**SUBJECT: Final Environmental Assessment for the Use of Department of Energy-Owned High-Assay Low-Enriched Uranium Stored at Idaho National Laboratory (CLN190431)**

# Environmental Assessment for Use of DOE-Owned High-Assay Low-Enriched Uranium Stored at Idaho National Laboratory

## **APPENDIX A – Comment Responses**

**Figure 2.** Actual and hypothetical public *receptor* locations for the air pathway analysis showing distance and direction from MFC and INTEC. Regulatory dose limits do not apply to the nearest boundary locations.

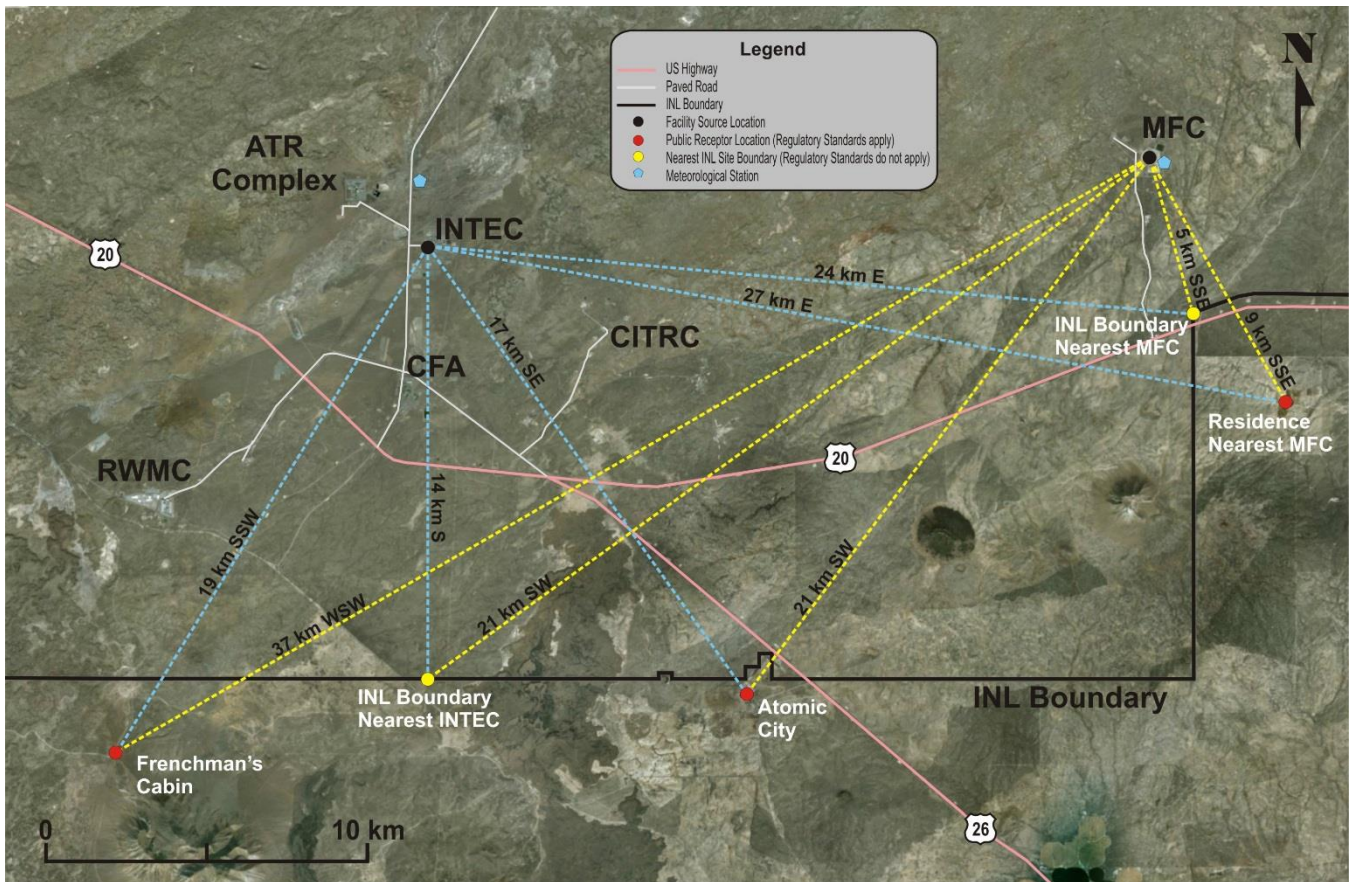
While the Tribes are concerned with any additional radiological emissions at INL, we are especially concerned with how radiological emissions will impact Tribal sacred sites at INL and Tribal members who may use those areas. In Figure 2 of the Draft EA, the DOE provided a map of actual and hypothetical public receptor sites. And Table 2 provides the effective yearly doses at various sites. But the Draft EA mentions neither what potential effective dose (ED) would occur at Tribal sacred sites like Middle Butte, nor the safety limit for Tribal members who go to Middle Butte for ceremonial activities. This should be included in the EA.

We might expect that the Total ED for Middle Butte would be slightly less than it is for the “Residence Nearest MFC.” At this site, Alternative 1b would create less Total ED—and presumably less ED at Middle Butte. Therefore, if those assumptions are correct, then Alternative 1b would yield less Total ED to the Middle Butte area. All else being equal, the Tribes would prefer the alternative that creates the least amount of radiological exposure to Middle Butte and other Tribal sacred areas.
